Our Ref: IPART Report - West Dapto 7.11 Contributions Plan
2020

**RE: Assessment of West Dapto Contributions Plan 2020 – Wollongong City
Council – Draft Report**

Figure 1: Proposed 7.11 Contribution Roads

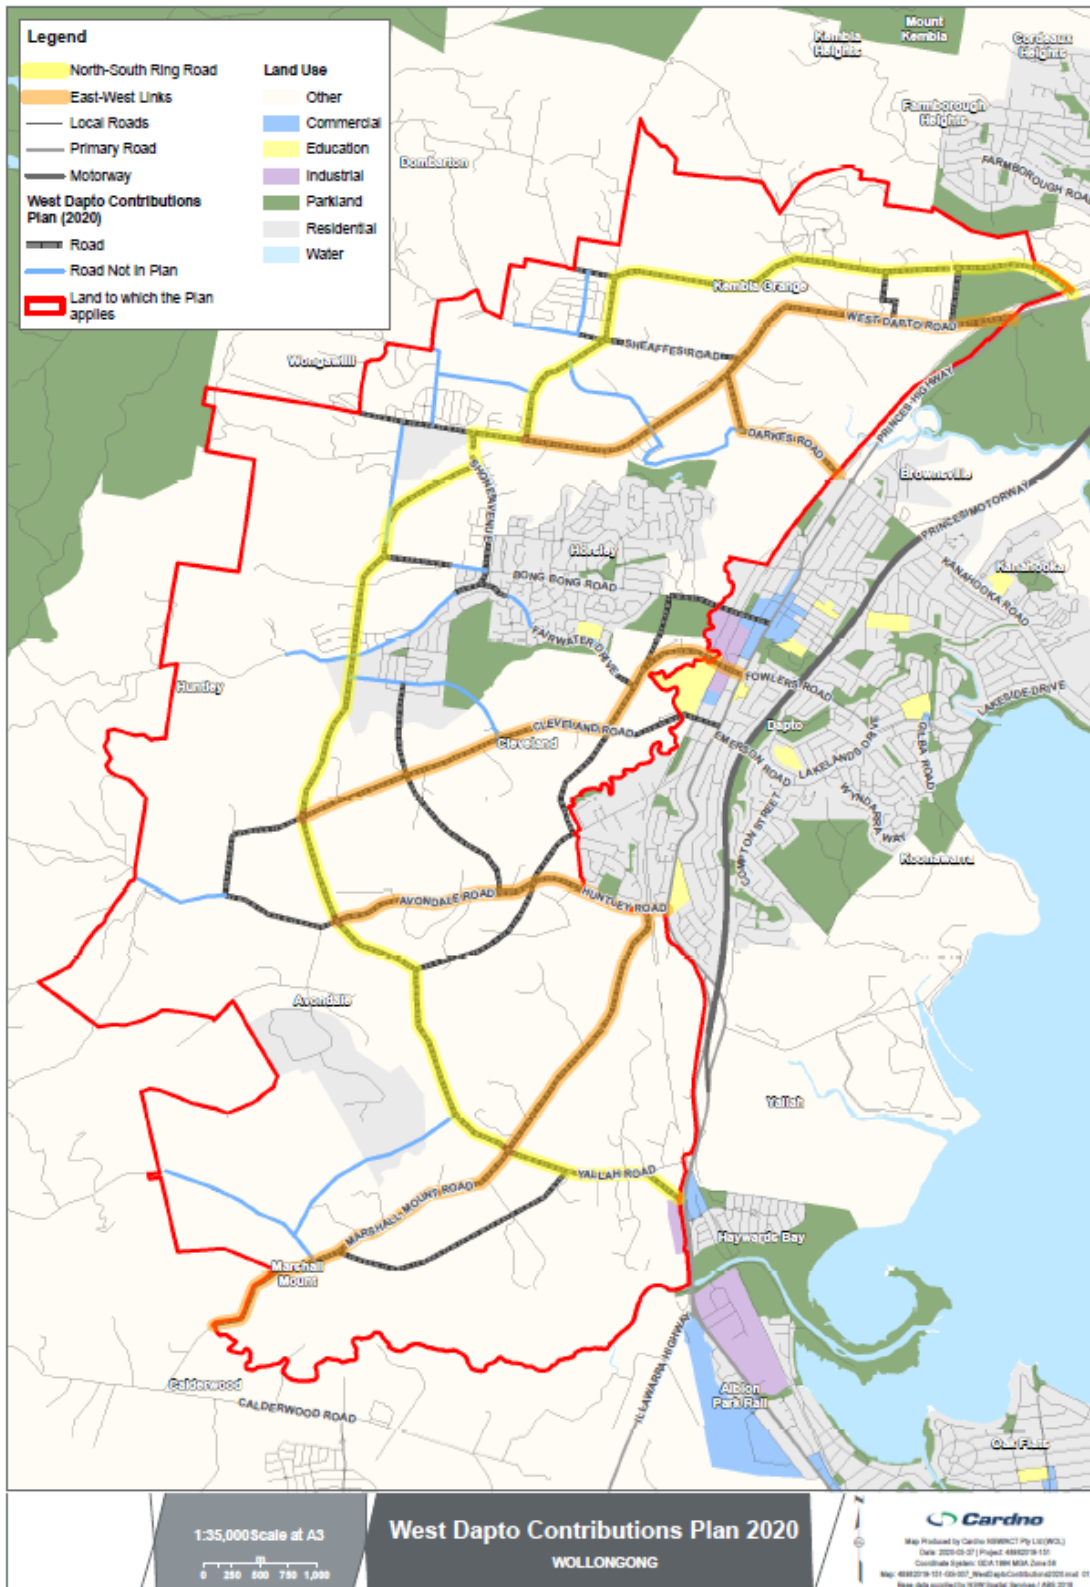
For additional clarity, Cardno has prepared a GIS Map of the roads they consider necessary to retain in the Plan. These roads have been highlighted in the map in **Figure 1** below, and include Northcliffe Drive extension, West Dapto Road, Cleveland Road, Avondale Road and Marshall Mount Road. This will give residents access to a north-south ring road, and a number of east-west connector roads, allowing easy access to/from the M1 Motorway or Princes Highway. Whilst the remainder of the roads as listed in the Plan are necessary roads which require upgrades, these could be delivered by the developers at a lower cost. Council has not shown sufficient need demonstrating the requirements of such local roads, and where these roads only access individual sites, they should not be included in the Plan. It is unreasonable to include these costs in area-wide contributions levied.
